A G E N D A

A regular meeting of the Planning & Zoning Commission of the City of Waxahachie to be held at the Waxahachie Civic Center, 2000 Civic Center Lane, Meeting Rooms A and B, Waxahachie, Texas, on ***Tuesday, September 15, 2026 at 7:00 p.m.***

"I move to approve SUB-105-2026, a Replat of the Hillcrest Addition, Lot 19R, Block 6, subject to the conditions of the staff report, authorizing the Planning & Zoning Commissioner to sign the associated documents accordingly."

*"I move to approve SUB-114-2026 for a **Replat** of Block A, Portion of Lot 1 of the Spirolite Addition, to create two (2) nonresidential use lots, subject to the conditions of the staff report, authorizing the Planning & Zoning Commission to sign the associated documents accordingly."*

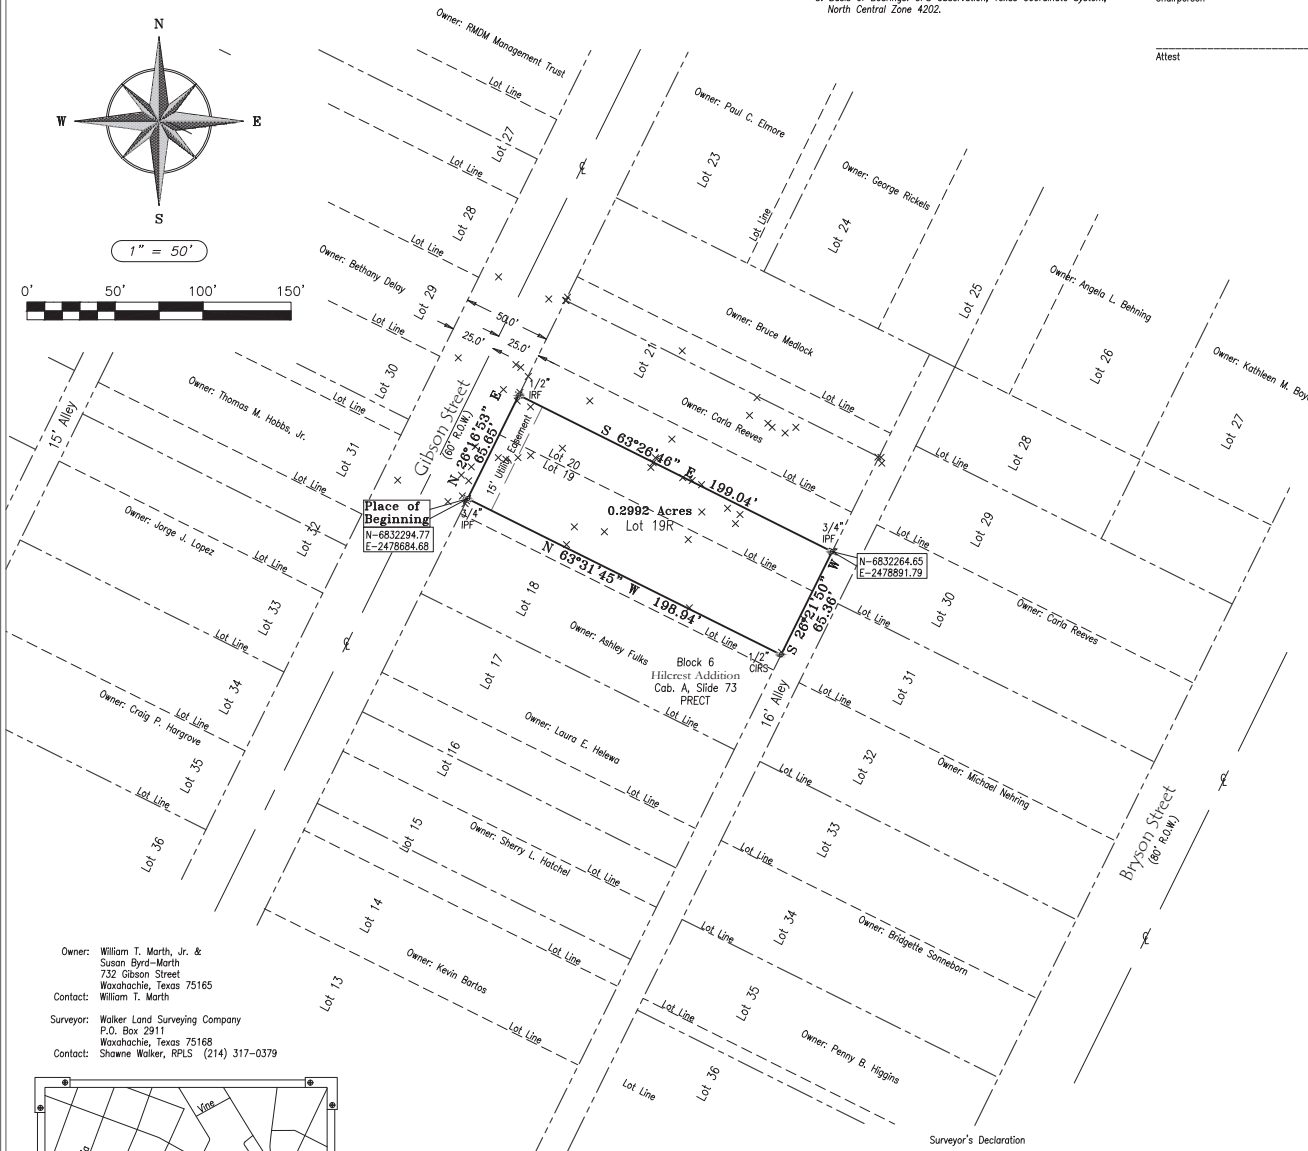
2. Per Section 2.4.C.4 of the Waxahachie Subdivision Ordinance: The location and width of all streets, alleys and easements, existing or proposed, within the subdivision limits and adjacent to the subdivision; a list of proposed street names shall be submitted for all new streets (street name approval is required at the time the plat is approved); Remove old lot line.

3. Per Section 2.4.c.23 of the Waxahachie Subdivision Ordinance, a correct title block is required to be provided. The correct case number for this plat is "SUB-105-2026", revise accordingly.

4. Per Section 2.25.iii of the Waxahachie Subdivision Ordinance, the correct owner name is required, the Plat errantly shows "Katie Holland" instead of "Susan Marth".

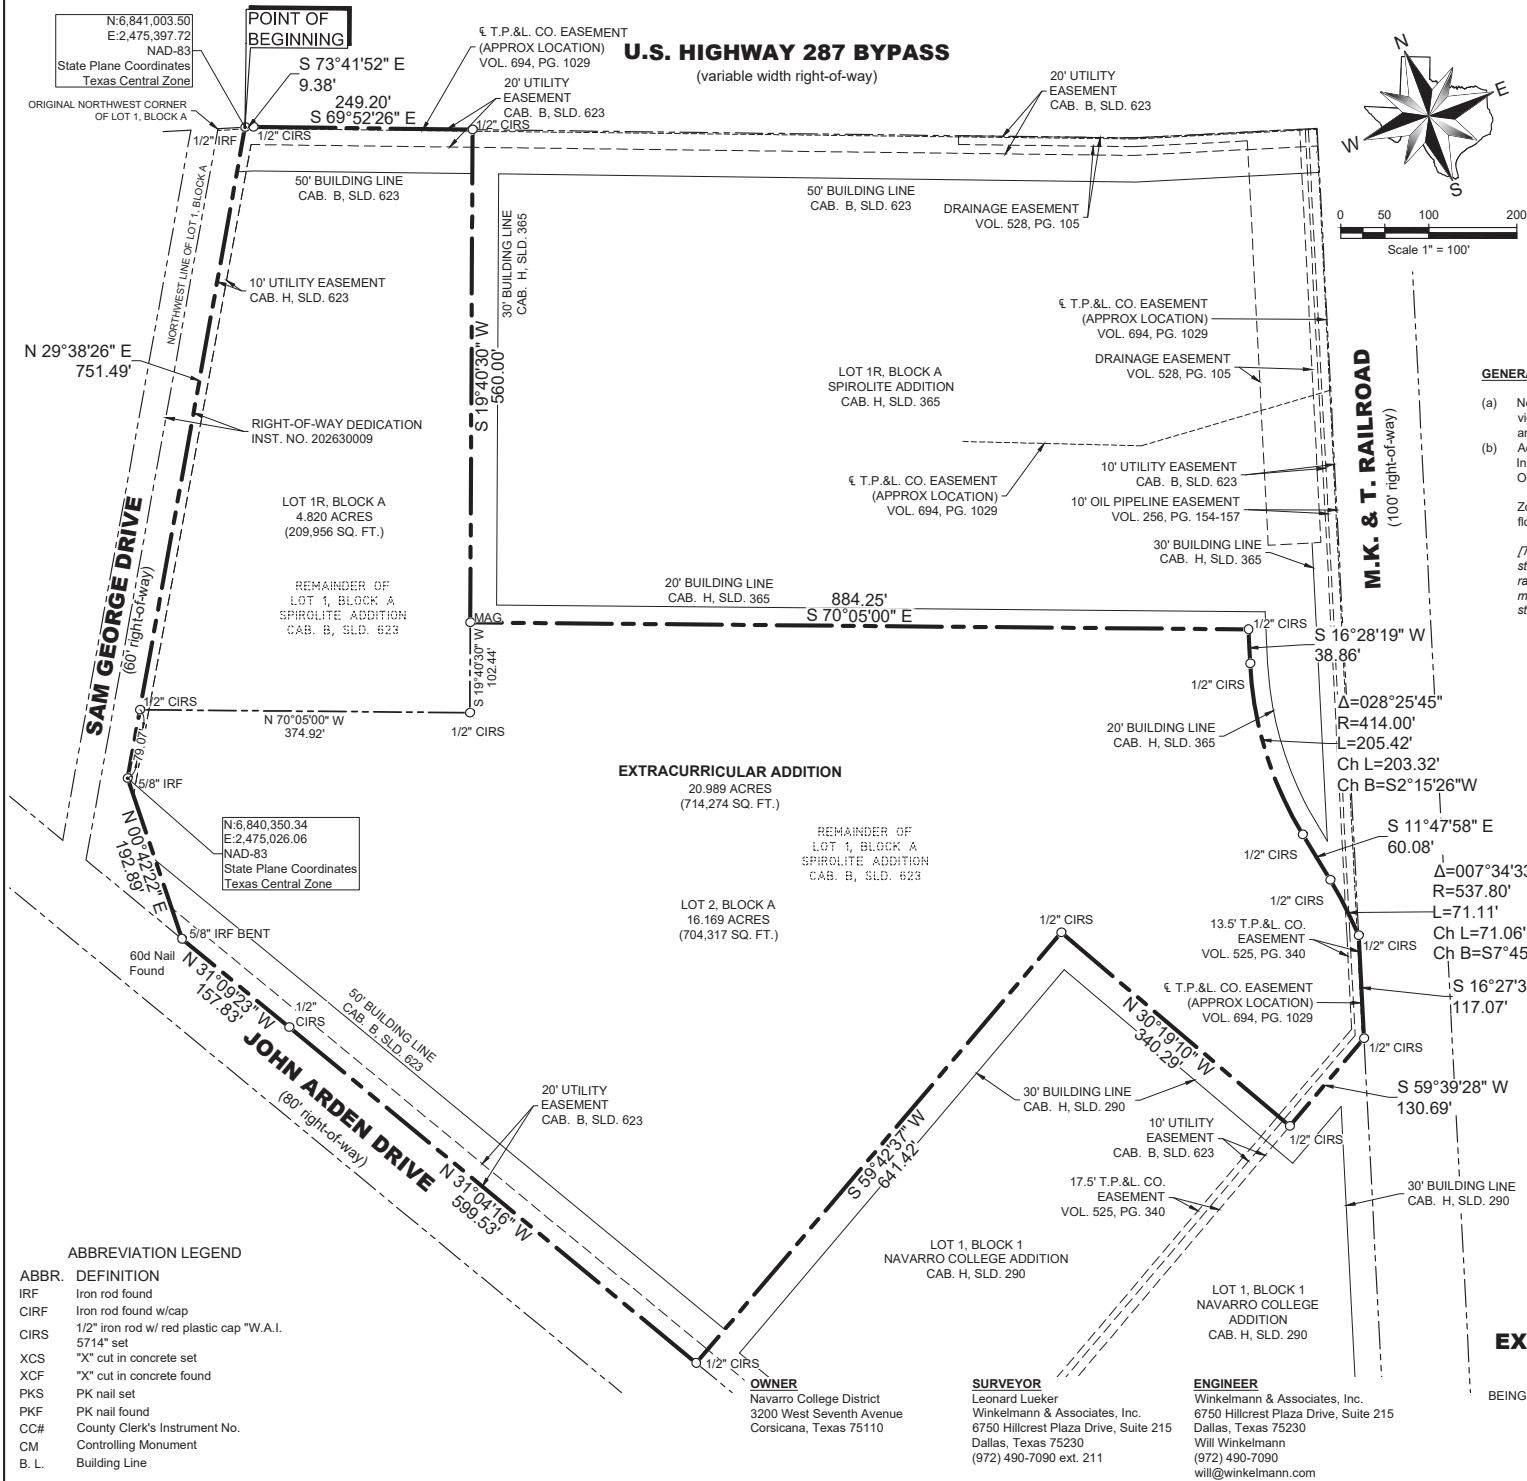
3. Per Section 2.4.c.7 of the Waxahachie Subdivision Ordinance, please remove the City from the owners list as the City does not own the subject property or portions of the subject property.

4. Per Section 2.4.c.25 of the Waxahachie Subdivision Ordinance, please remove the City from the Owners Certificate as the City does not own the subject property or portions of the subject property.

5. Per Section 2.4.c.25 of the Waxahachie Subdivision Ordinance, please replace "...the remainder of Lot 1" to "...a portion of Lot 1" on the Owner's Certificate. Please see replat markup.

6. Per Section 2.4.c.25 of the Waxahachie Subdivision Ordinance, please update the info to reflect the individual(s) who will sign this plat.
7. Per Section 2.4.c.25 of the Waxahachie Subdivision Ordinance, the Surveyor's Certificate does not need to be notarized. Please remove.

8. Per Section 2.4.c.25 of the Waxahachie Subdivision Ordinance, please update the approval block for the Planning & Zoning Commission.
9. Per Section 2.6.j of the Waxahachie Subdivision Ordinance, the title shall identify the document as "...BEING A REPLAT OF A PORTION OF LOT 1, BLOCK A OF THE SPIROLITE ADDITION... CASE NUMBER: SUB-114-2026". Please see replat markups.

10. Per Section 3.3.a of the Waxahachie Subdivision Ordinance, a 15' UE is required adjacent to all street rights-of-way (ROW).
11. Per Section 3.3.e of the Waxahachie Subdivision Ordinance, provide the necessary Access Easement(s). Consider overall development and the access connections expected to be made with adjacent properties as development occurs.

12. Per Section 3.3.e of the Subdivision Ordinance, provide the necessary Utility Easement(s). The City's infrastructure records indicate the subject property has access to an off-site sewer line in this area (shown in green). If the subject property will utilize the off-site sewer line, the line must be improved to public design standards and a public utility easement be dedicated conditional to the approval of the City.

13. Per Section 3.3.e of the Subdivision Ordinance, provide the necessary Access Easement(s). It appears the subject property is currently sharing access with Lot 1 of the Navarro College Addn.

1 EAST ELEVATION
SCALE: 1/8"=1'-0"

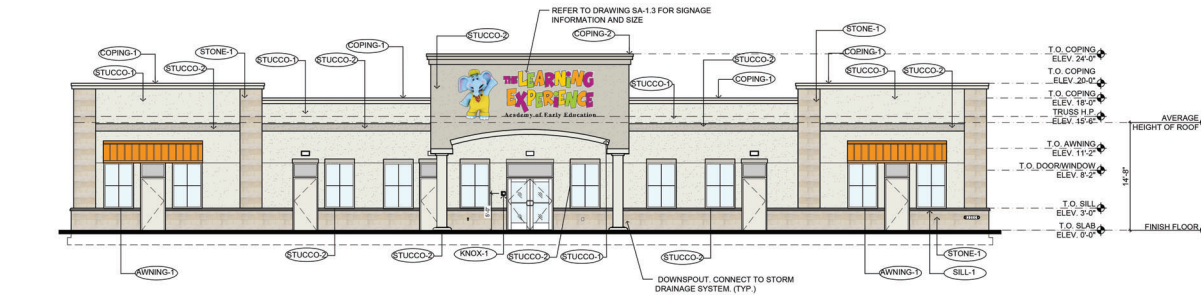
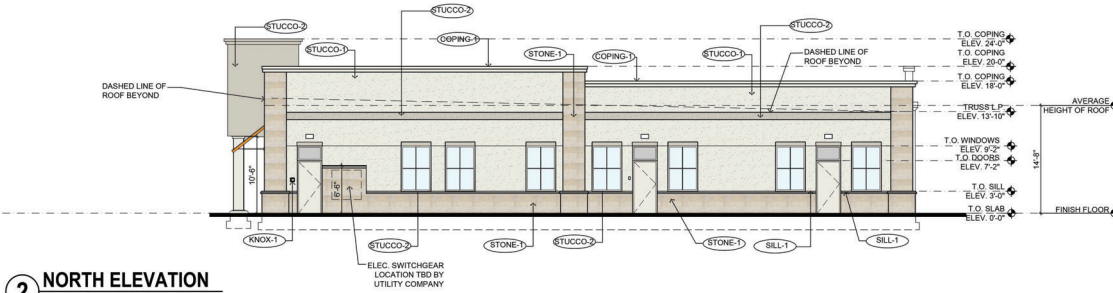
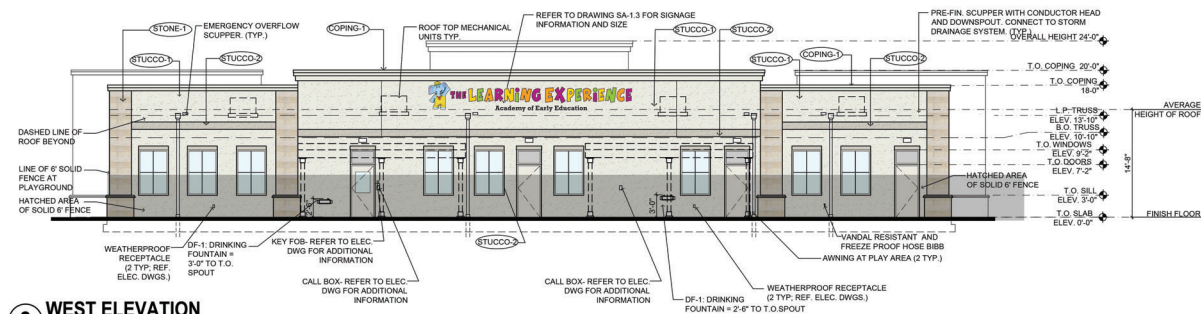
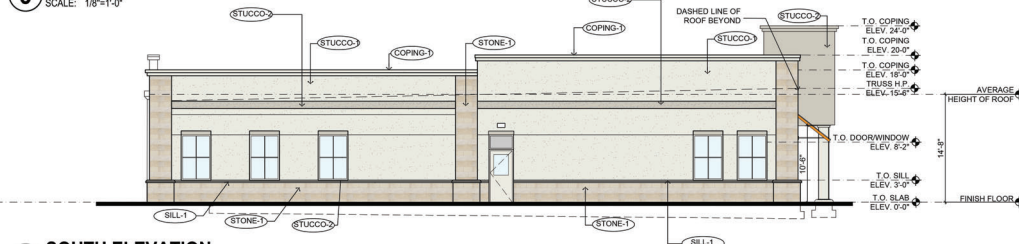
Staff supports the requested SUP application request and the deviation from the Sign Regulations of the Waxahachie Zoning Ordinance, as an alternative design that can provide adequate site visibility to the subject property while remaining generally consistent with the intent of the ordinance, provided the Applicant complies with the minimum glazing requirements.

Staff's support for the signage deviation is contingent upon compliance with the building design and glazing requirements, as the proposed structure is intended to remain on site in perpetuity and should complement and enhance the surrounding development pattern. While signage on the structure may change as future tenants come and go, the building itself will remain. Accordingly, staff seeks to maintain a high-quality architectural appearance and ensure the structure retains long-term adaptability for future commercial occupancy.

Per Section 5.01(b)(iv)(7)(b)(v) of the City of Waxahachie Zoning Ordinance, which requires windows and glazing to comprise a minimum of 30% of each building elevation, Ownership requests approval of a 20% blended average across all elevations. This request was previously reviewed and supported by the Planning and Zoning Commission, and Ownership respectfully asks that this prior professional review inform the City Council's reconsideration.

1. The Applicant shall meet the minimum requirement of 30% glazing per elevation.
2. The Applicant may exceed the sign face area by 2.5 square feet as described in the Planning Analysis herein.
